APPENDIX C

HERITAGE REVIEW

Hornsby Aquatic Centre Redevelopment

WEIR PHILLIPS
Architects & Heritage Consultants

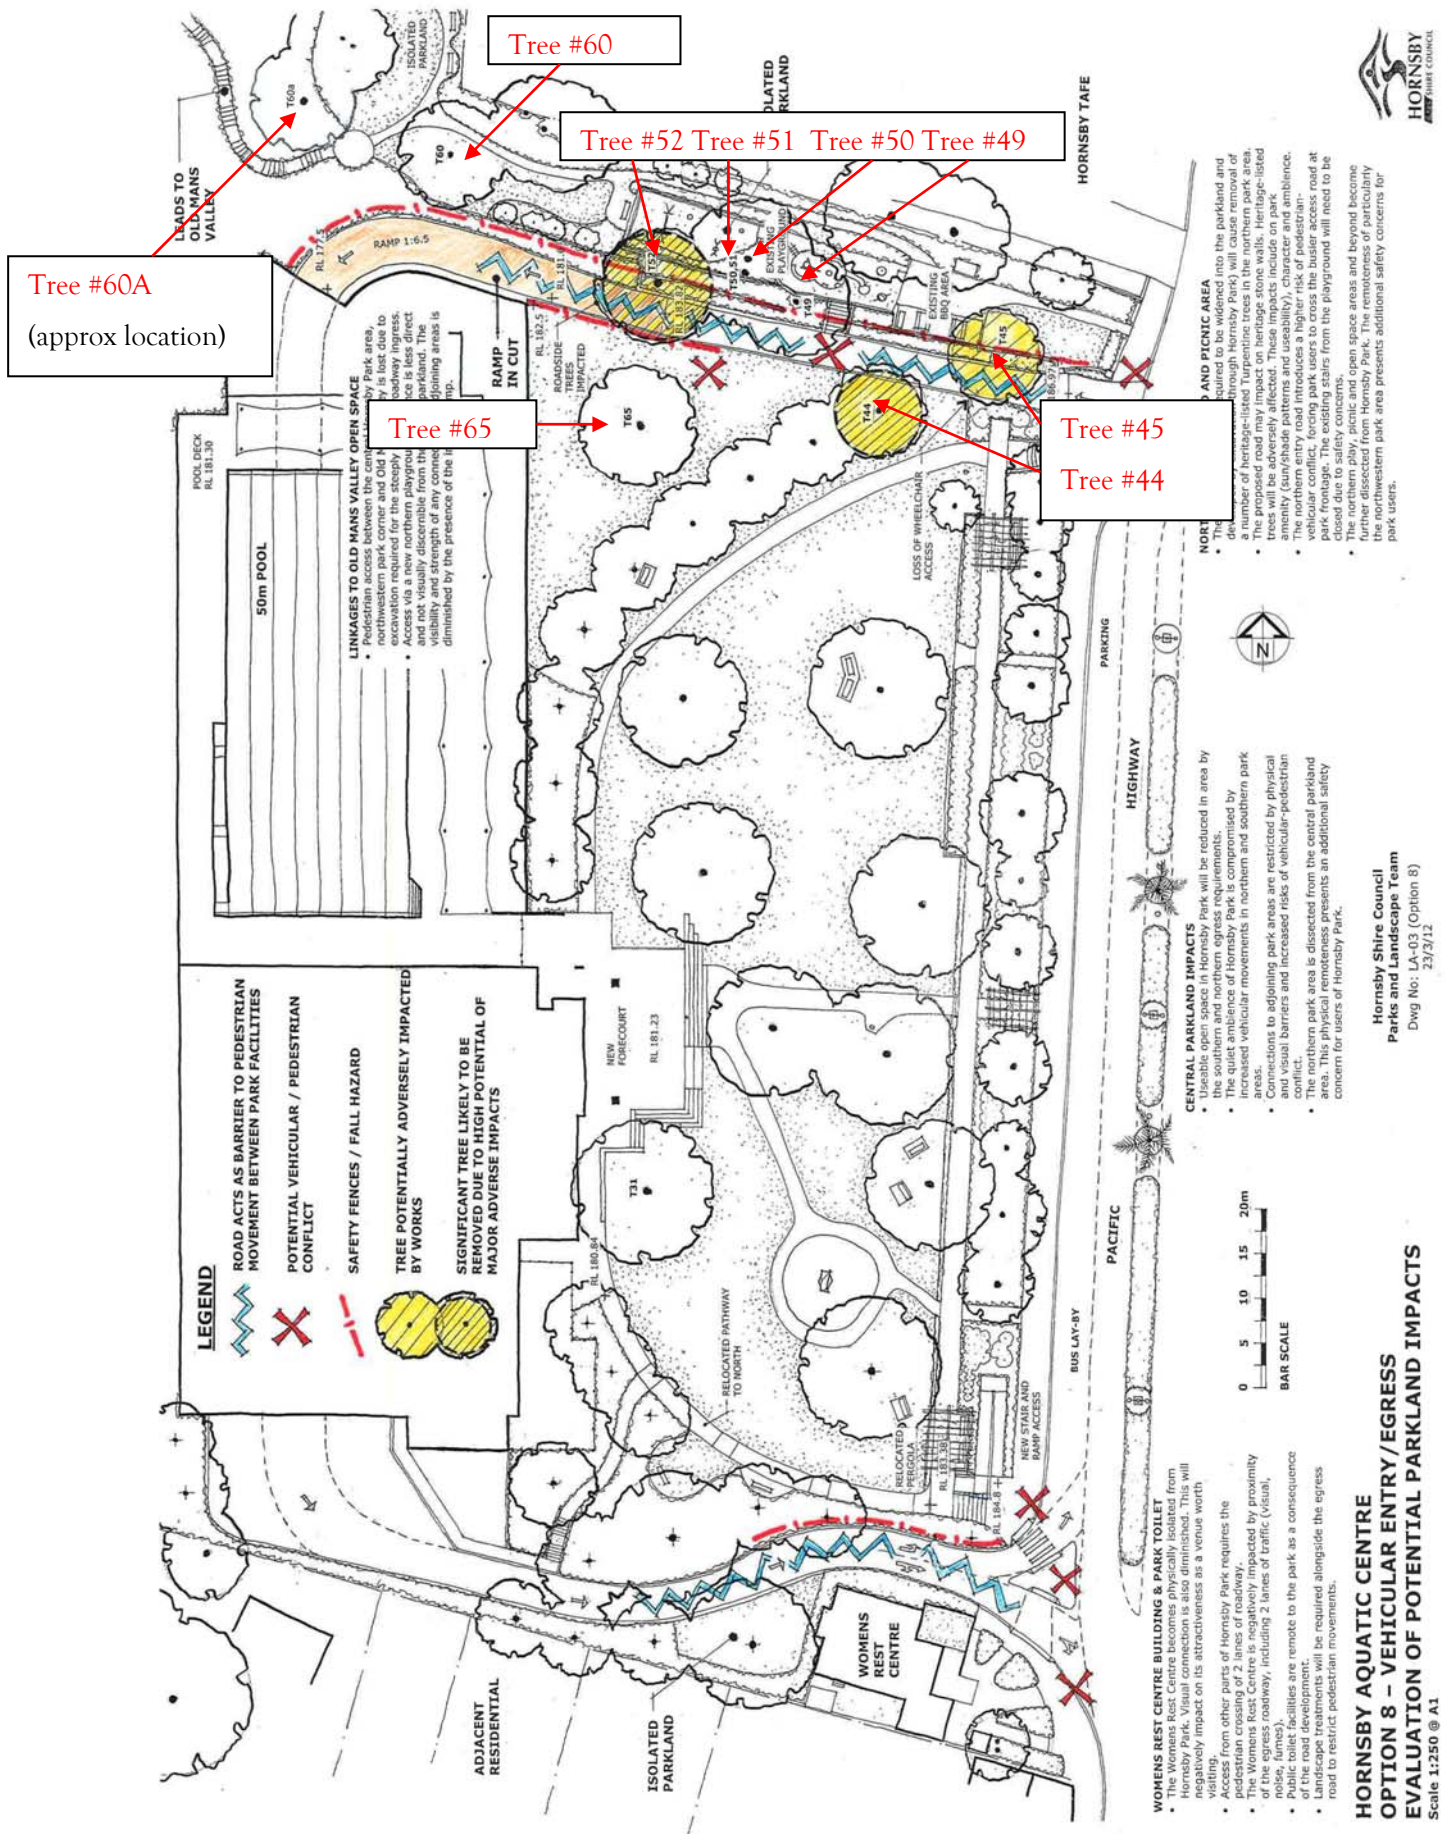
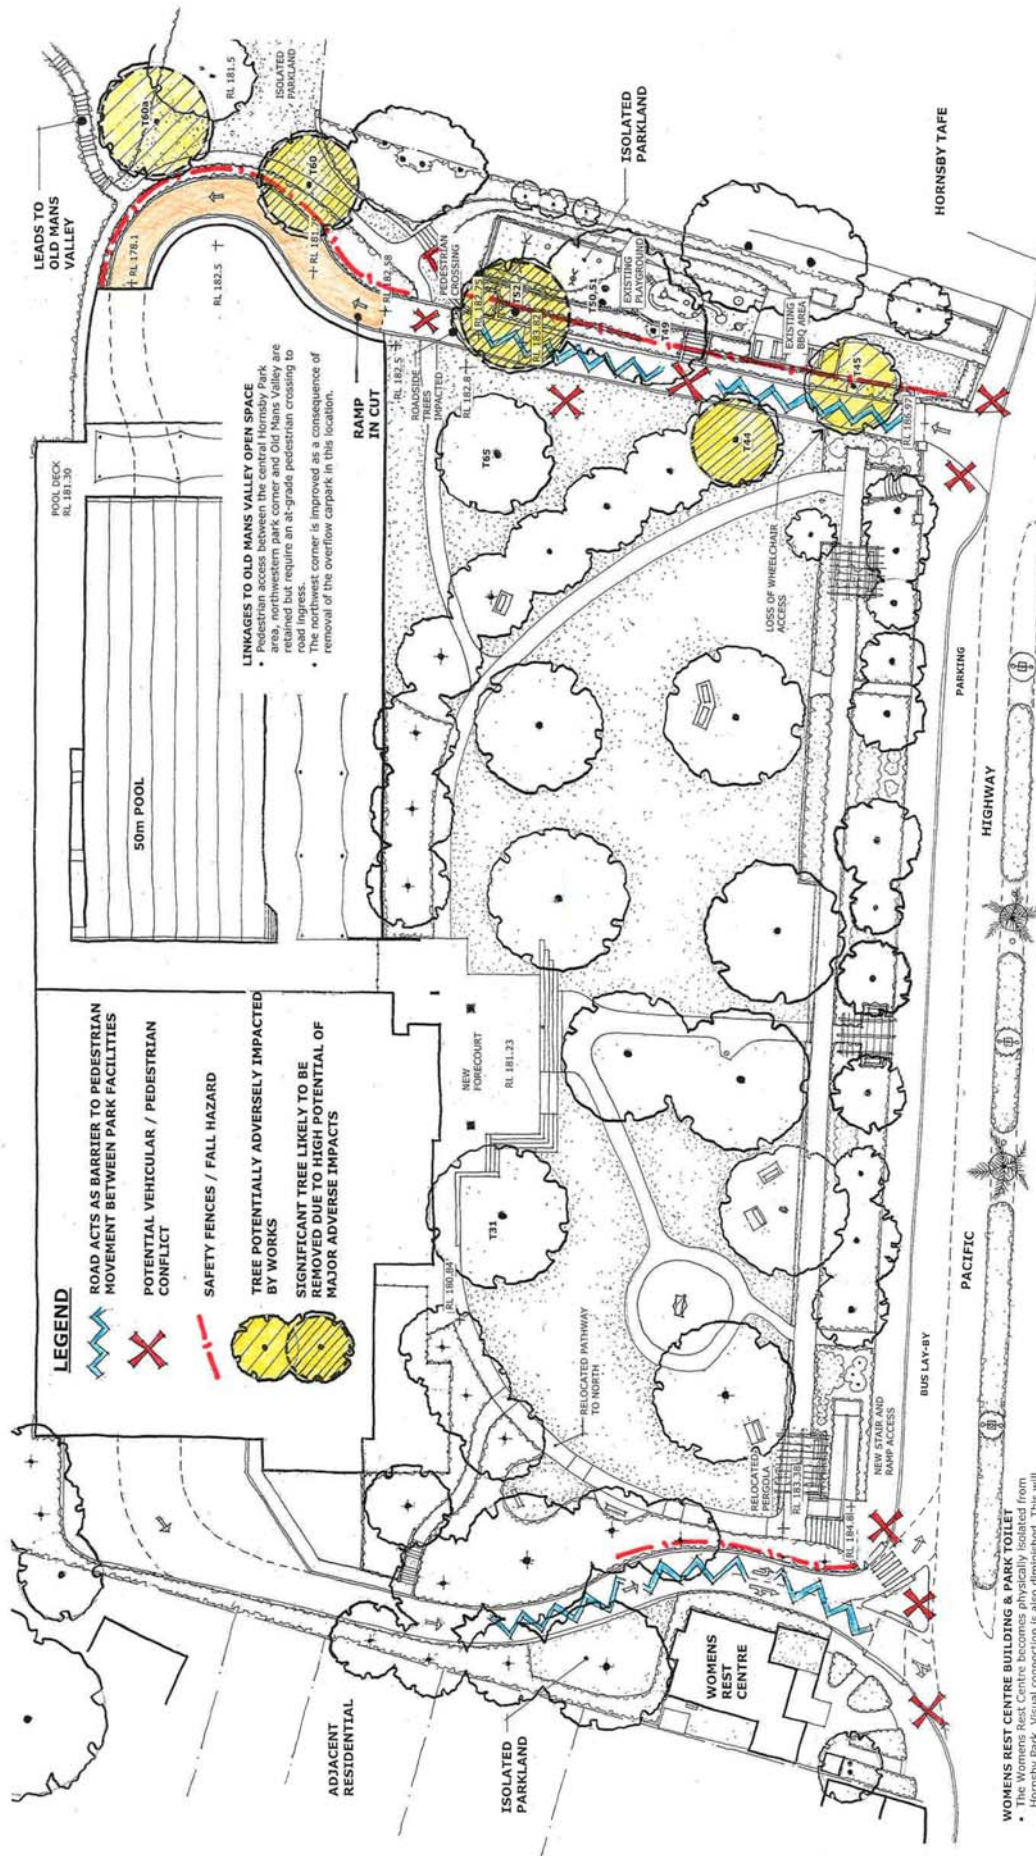
The calculated *TPZ radial distance of 12.0m for Tree #44* is noted to be significantly breached. It is possible the breach may be proven to be manageable. This however can only be confirmed with a root location investigation.

- ❖ Option 8b does not require major excavation relative to the existing & proposed roadway slope within Tree #52 calculated *SRZ radial distance* of 3.47m.
Potential "significant diameter roots" (i.e. roots greater than 0.05m/50mm in Ø) belonging Tree #52 have already damaged the existing roadway & are likely to be damaged by any roadway resurfacing required.
- ❖ Option 8b if implemented is not assessed to have any significant adverse impact to Tree #60A. This tree is assessed as being in the early stages of decline (dead branch tips), most likely the result of significant *SRZ/TPZ radial distance* change of soil levels some years ago.
- ❖ Option 8b if implemented will require the construction of a "*Bailey's Bridge*" or similar over the calculated *TPZ/SRZ radial distance* of any retained tree.
